APPENDIX A: Consultation Responses and Representations

Consultee Consultation Responses

Part A - Full application for the change in use of 25.6 ha of land at Alderbourne Farm to form a nature reserve with footpaths, biodiversity enhancements, associated parking and infrastructure. Outline application with all matters reserved (except for principal points of access) for land at Alderbourne Farm for backlots and up to 35,000 sqft (3,252 sqm) of associated film production buildings (workshops) together with access roads and parking.

Part B - Outline application for Pinewood South on 32.6 ha of land with all matters reserved (except for three principal points of access) for up to 1,365,000sqft (126,817sqm) of film production buildings (to include sound stages, workshops, offices and ancillary uses), education and business hubs with associated ancillary structures together with backlot, multi storey car parks, accesses and green and blue infrastructure.

Extract 5 – from Green Infrastructure Plan

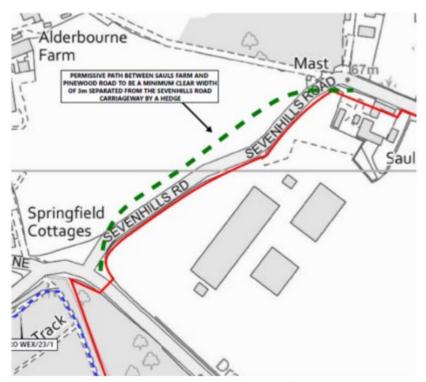
My route 2 [Extract 5] connects with the frontage of Field Lodge opposite Saul's Farm on Seven Hills Road and the wider permissive path network provided by Pinewood. This is east of point B on Extract 4 and shown more widely by the permissive footpaths secured through the Pinewood east s106 Agreement, illustrated on Extract 6, with a later amendment on Extract 7. This is welcome.
